SHERWOOD PROJECT

**RE: Radioactive Materials License WN-I0133-1; License Condition No. 29:
Request for Termination of License WN-I0133-1 Issued for the Sherwood
Project Operated by Western Nuclear, Inc.**

**REQUEST FOR LICENSE TERMINATION
FINAL DATA SUBMITTAL**

TAILING RECLAMATION PLAN COMPLETION REPORT OUTSTANDING ADMINISTRATIVE ISSUES

FIGURE 1

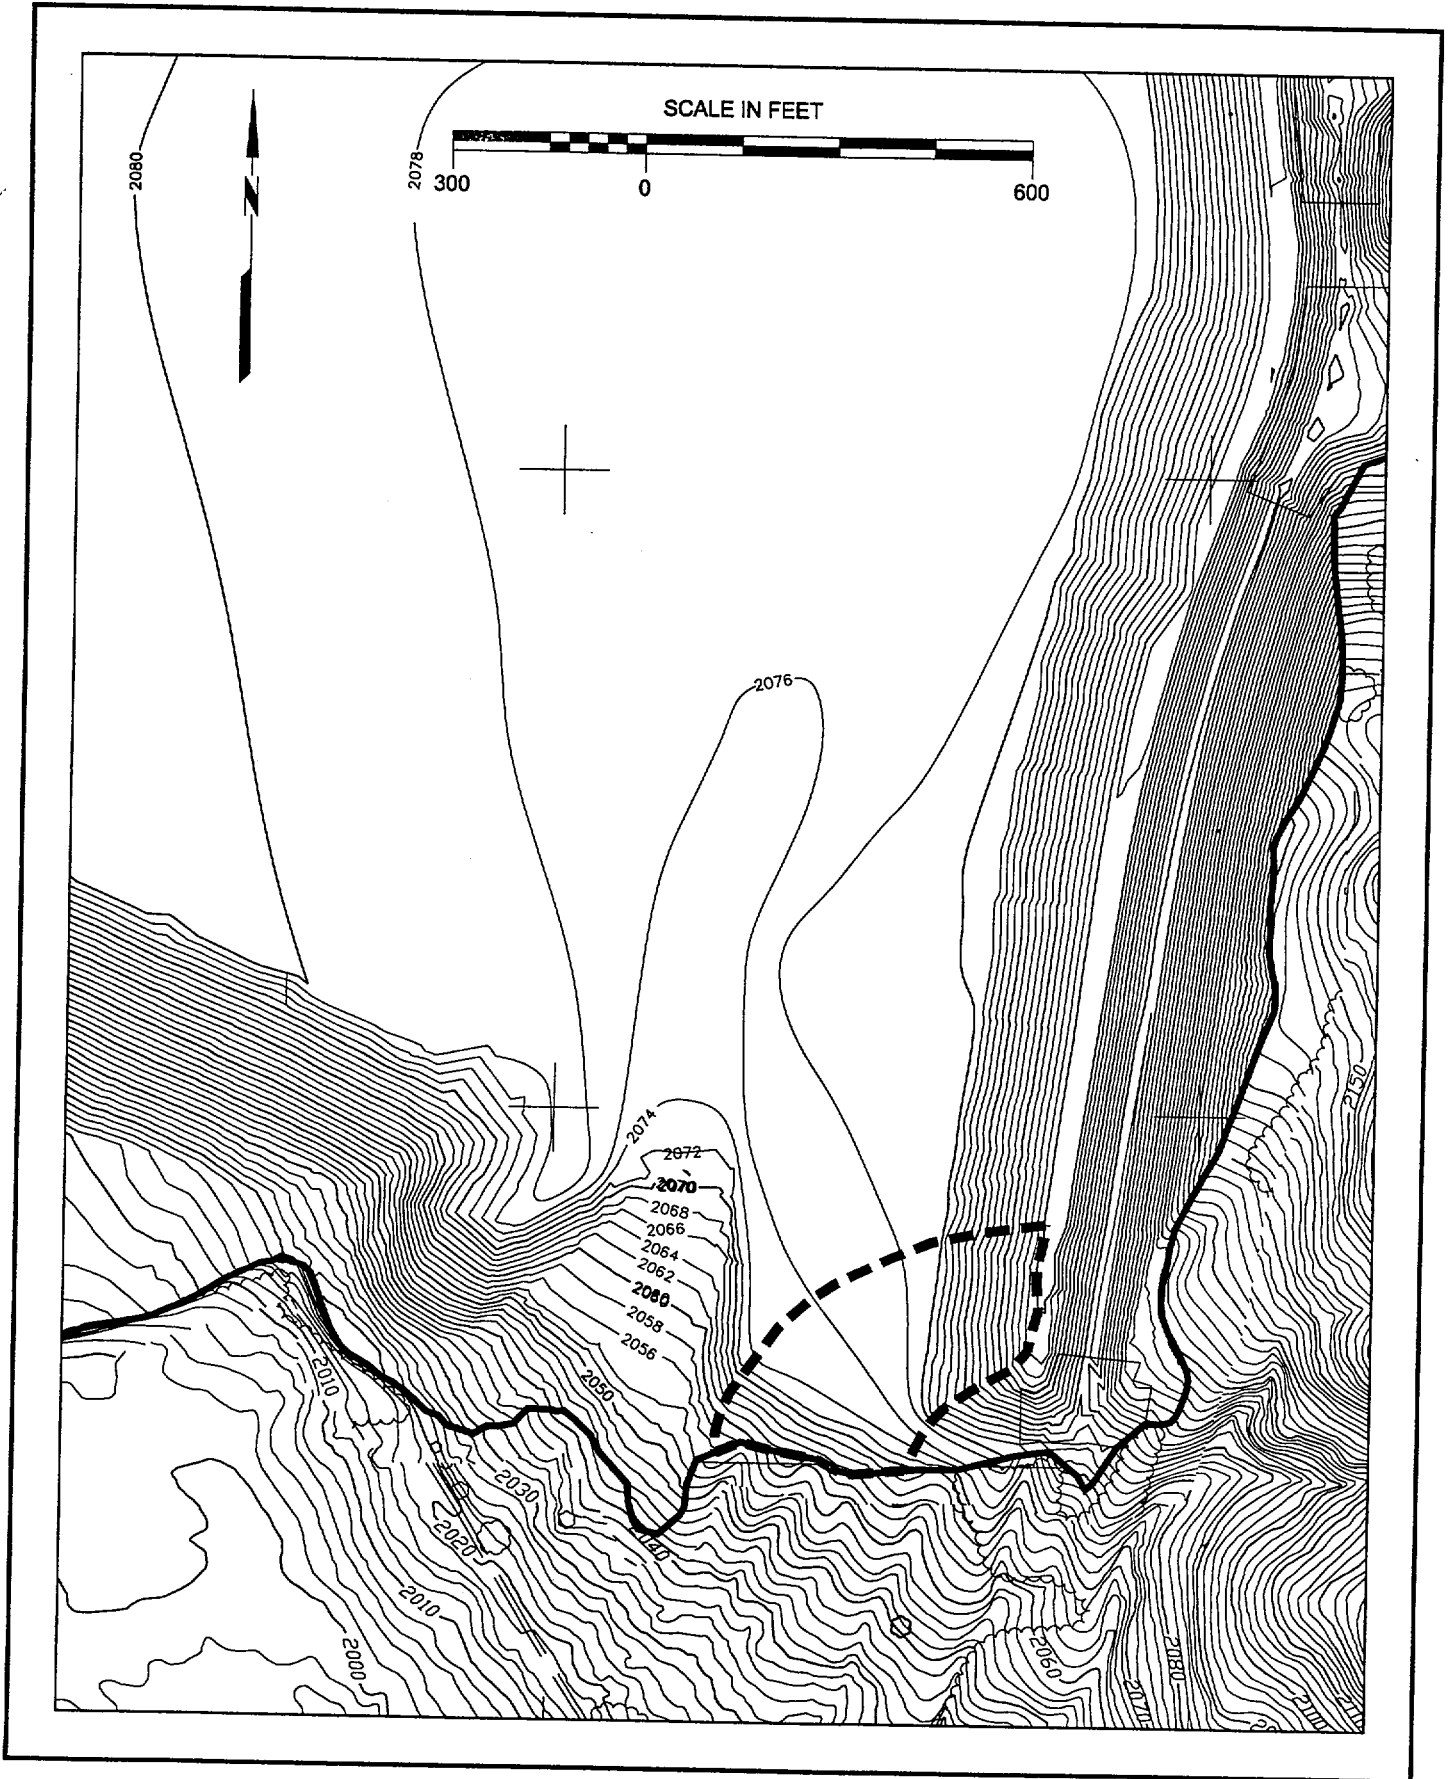
RESPONSE

There is a small area (approximately 3 acres) between the swale outlet and the margin, as shown on Figure 1, that drains to the south. This drainage configuration is consistent with the original design. As the regraded gentle slope transitions into the steeper natural topography, a small amount of gullying and general erosion is apparent. This erosion will not, however, impact the reclaimed tailing impoundment. Any head-cutting would be limited to the small drainage basin, which is at least 700 feet from the edge of the reclaimed tailing surface. Additionally, quartz monzonite bedrock is at or near the surface for much if not all of this small drainage basin and therefore any gullying would be limited to a depth of only a few inches.

FIGURE 1
TYPICAL CROSS SECTION

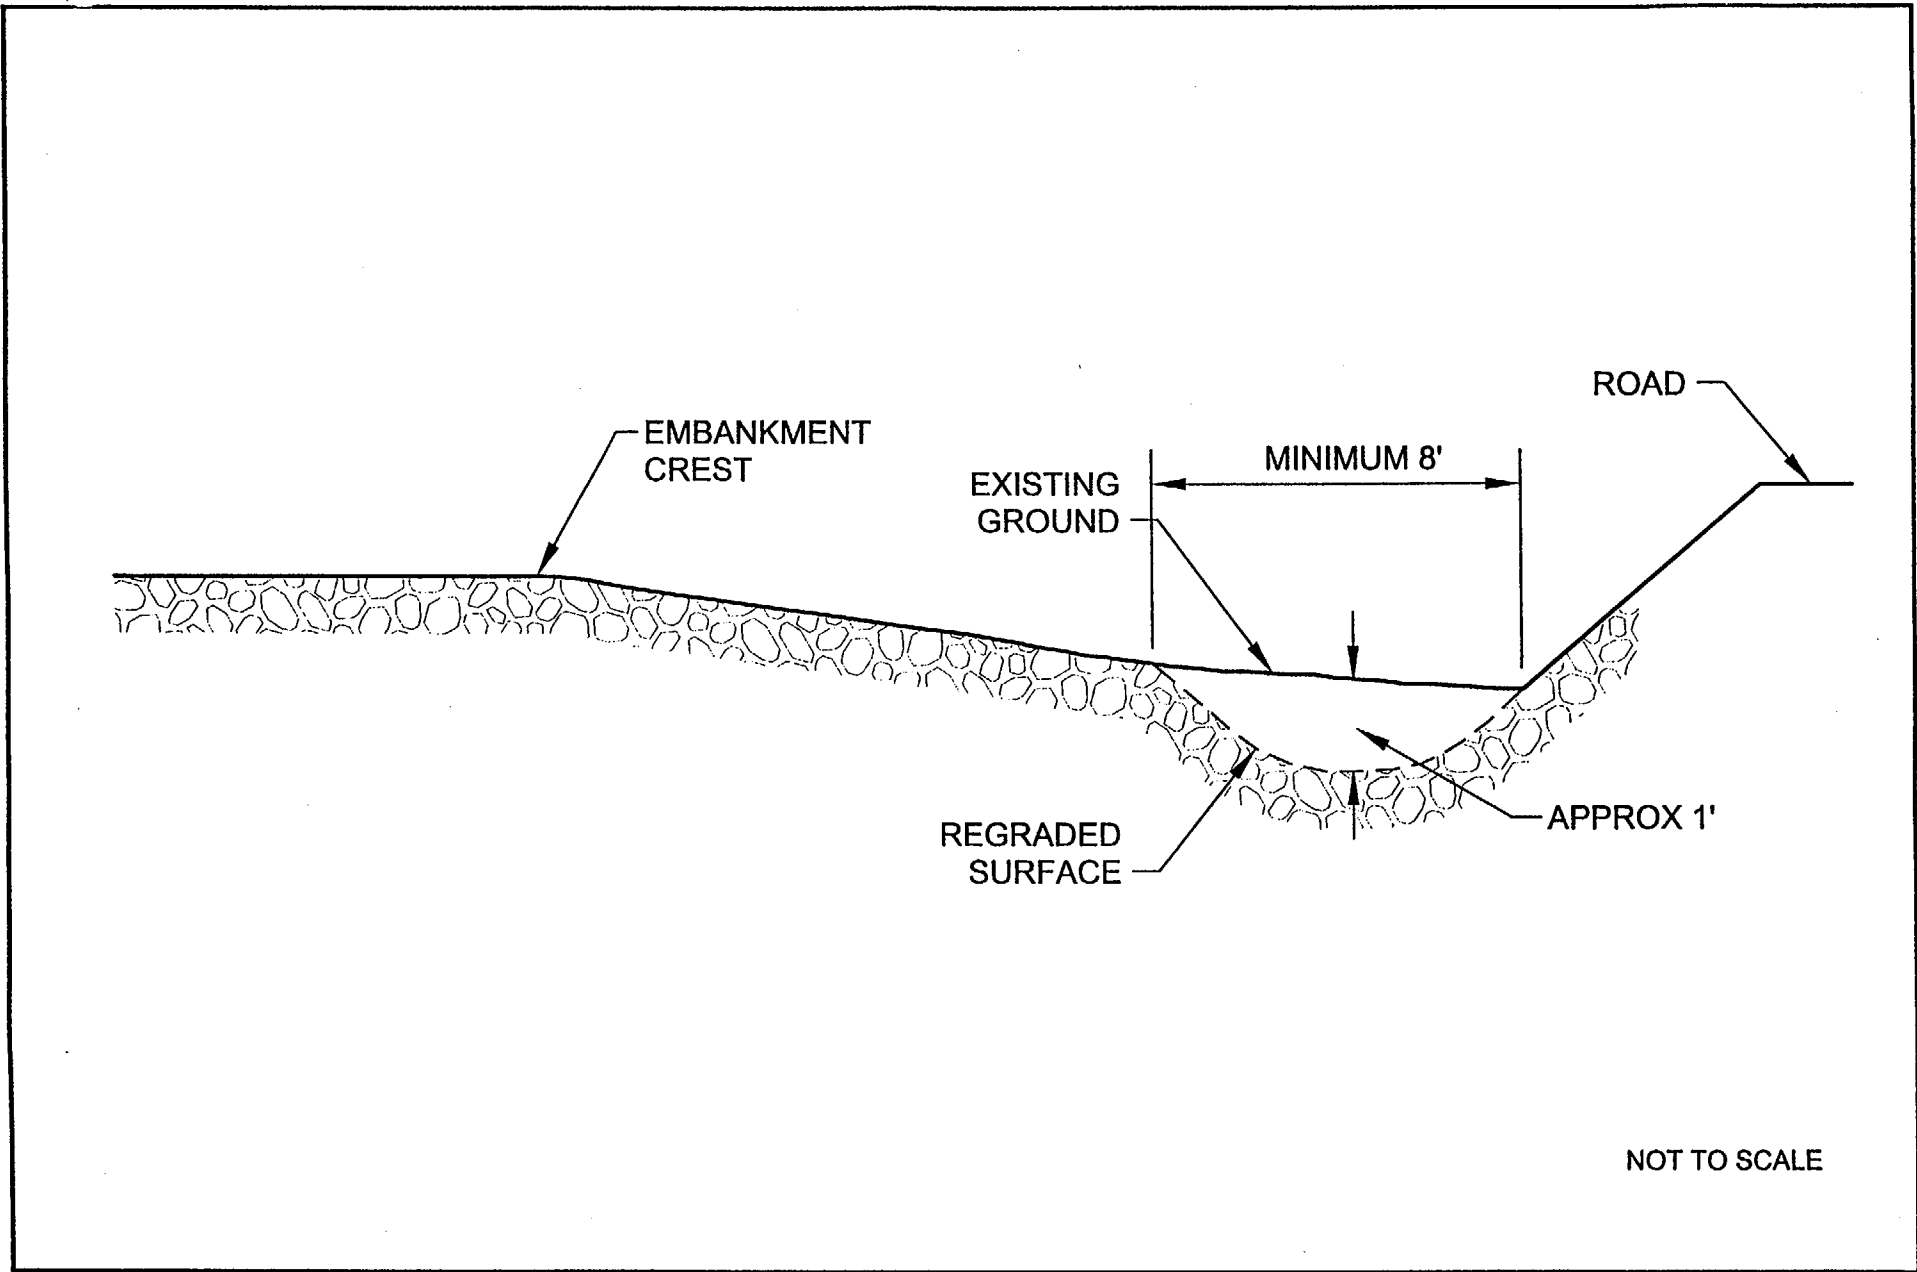
This letter is in response to your letter dated September 21, 1999 regarding surface stability inspection issues at the Sherwood project site. Specifically this letter presents the required design to address the regrading activities for Issue 1, the area immediately west of the reclaimed embankment and Issue 3, the reclaimed northwest borrow area.

As discussed during our site inspection on September 7, 1999 this concern will be addressed by enlarging the existing drainage to the south to keep drainage water away from the groin area. This will be done by removing the existing rock in the drainage, excavating the subsoil material and replacing the existing rock. Figure 1 depicts a typical cross section of the reconfigured drainage.

FIGURE 5.1
DIVERSION CHANNEL
SCHEMATIC

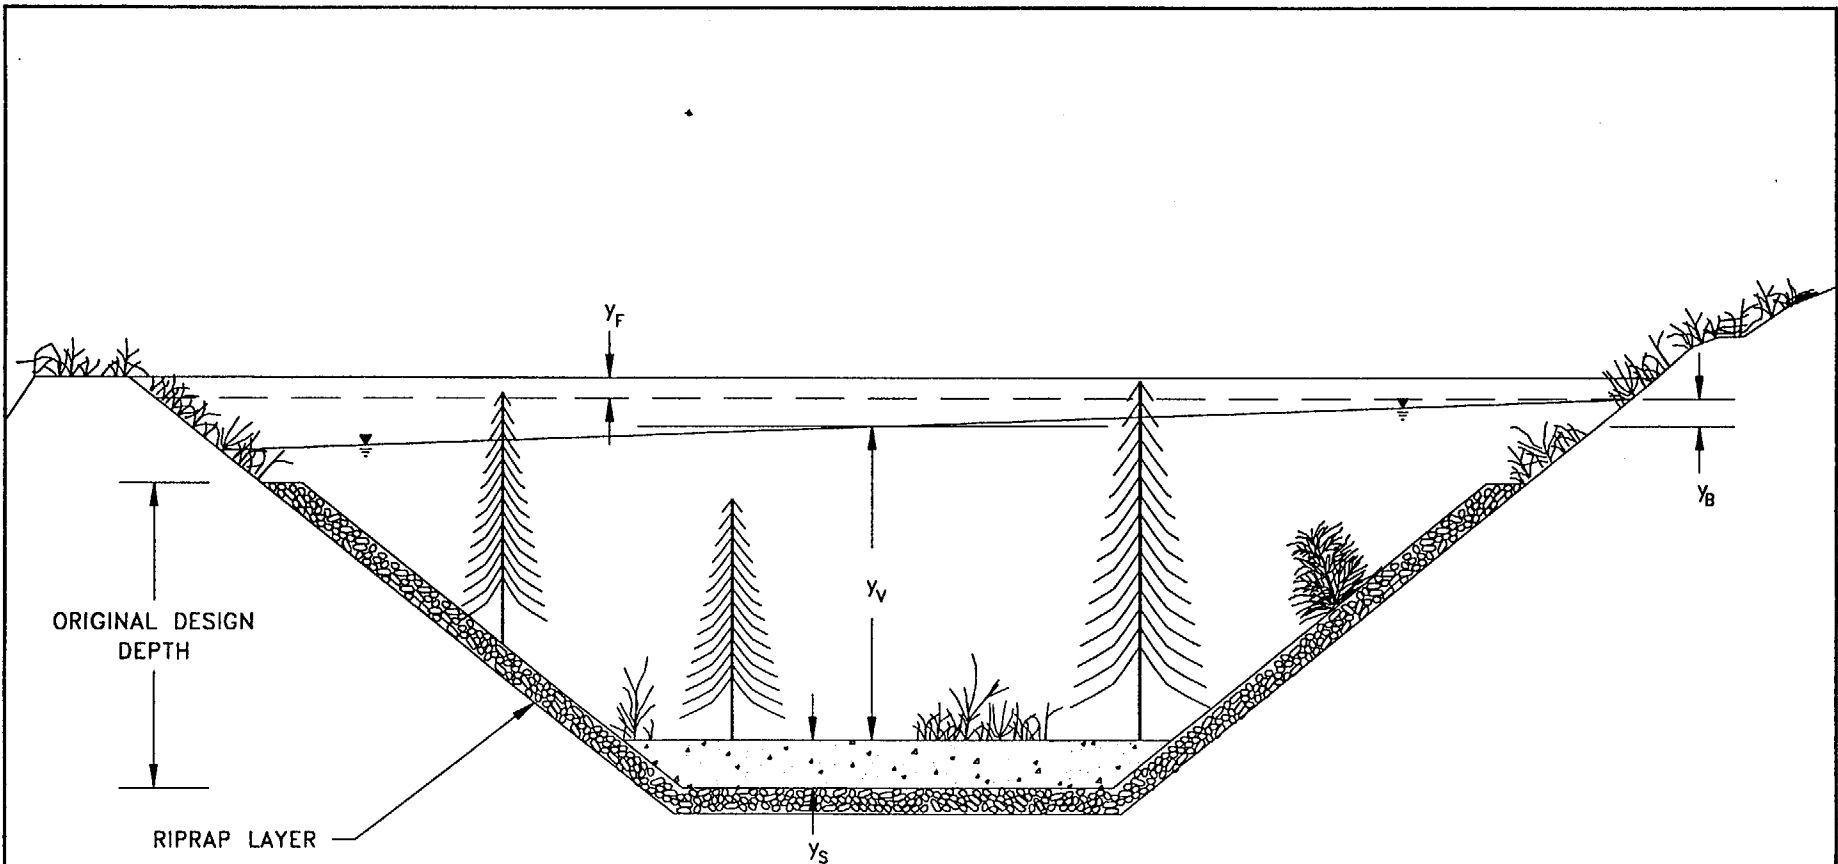
The following section evaluates the impact on diversion channel capacity of sediment accumulation combined with the impact of vegetation growing in the channel. Modifications to the diversion channel design are presented in Section 5.

Since relocation or deletion of the diversion channel are not beneficial alternatives, modification to the diversion channel design in the 12/94 TRP, is proposed to ensure that the channel will contain 1) 2.0 feet of sediment deposited on the bed, 2) PMF flows through a vegetated channel as modeled by HEC-2 with Manning's n equal to

0.10, 3) superelevation, and 4) 1.0 foot of freeboard. The 1.0 foot of freeboard in addition to considerations for sediment, vegetation, and superelevation, is a final degree of conservatism and provides significant cross sectional area to the channel should it be needed. For example, at the downstream end of the channel, the depth is 22 feet and the top width is 140 feet wide. The cross sectional area in the upper 1-foot of channel is about 137 square feet. This area corresponds to a depth of over 5.8 feet at the bottom of the channel. Therefore, there could be as much as 5.8 feet of sediment in the channel and the PMF would still be contained within the channel freeboard.

Figure 5.1 shows the modified channel design schematically. The design of the diversion channel is proposed to be modified by increasing the amount of compacted fill on the berm between the channel and the tailings impoundment. Table 5.1 summarizes the changes in design depth for the channel, comparing channel depth as presented in the 12/94 TRP to the modified channel depth designed for sediment, vegetation and superelevation. Table 5.2 is a more detailed summary of the issues investigated in this response report.

FIGURE O-1
SHERWOOD PROJECT
TAILINGS SWALE OUTLET APRON SLOPE

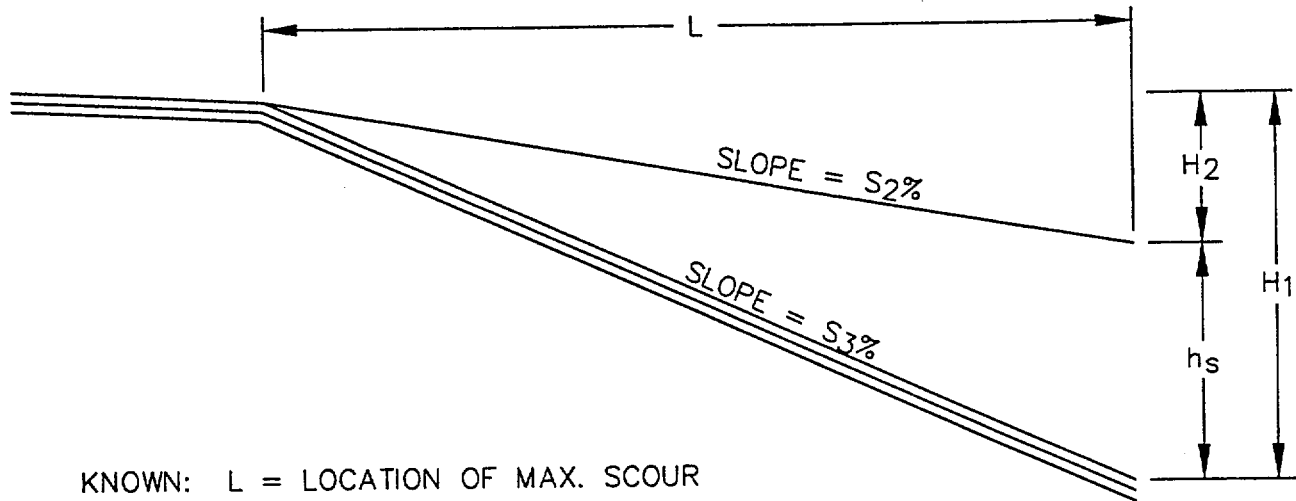
(a) The design slope in Drawing 7 of the WDOH approved November, 1996 Technical Specifications is shown as 15%. This slope was calculated by dividing the scour depth h_s (4.5 ft) by the length (L)(30 ft). This value is incorrect because as shown in Figure O-1, the slope is equal to the depth H_1 divided by L. As discussed below the correct slope is 21%.

As illustrated in Figure O-1, the slope of the tailing swale apron (S_3) is equal to the depth H_1 divided by the length L. However, since the value of H_1 is not known, it is necessary to derive an equation for S_3 in terms of the ground slope S_2 and the scour depth h_s , which are known values. The equation as derived on Figure O-1 is as follows:

The swale apron slope is shown in Drawing 7 of the November 1996 Technical Specifications as 15%. This value is in error because as stated in the footnote in Table O-1, an incorrect depth was used in the slope calculation. Using the equation above results in a correct slope of 21%.

FIGURE 1
TYPICAL CROSS SECTION

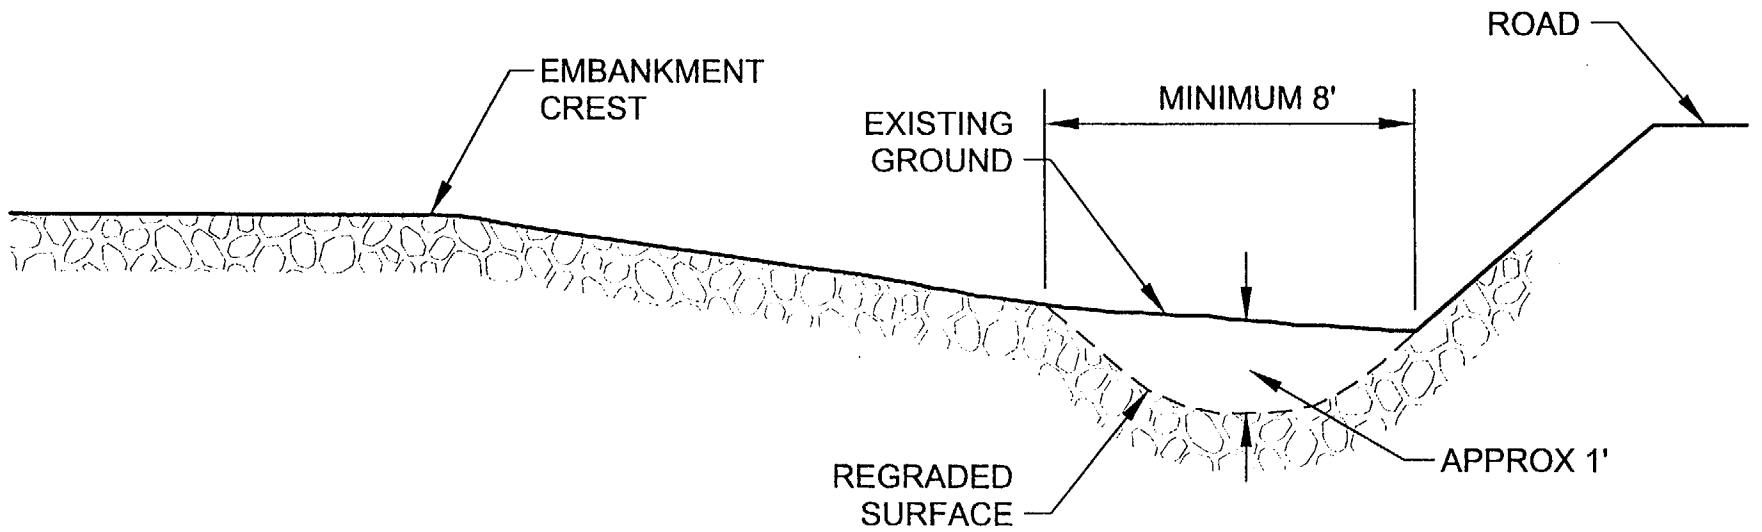
This letter is in response to your letter dated September 21, 1999 regarding surface stability inspection issues at the Sherwood project site. Specifically this letter presents the required design to address the regrading activities for Issue 1, the area immediately west of the reclaimed embankment and Issue 3, the reclaimed northwest borrow area.

As discussed during our site inspection on September 7, 1999 this concern will be addressed by enlarging the existing drainage to the south to keep drainage water away from the groin area. This will be done by removing the existing rock in the drainage, excavating the subsoil material and replacing the existing rock. Figure 1 depicts a typical cross section of the reconfigured drainage.
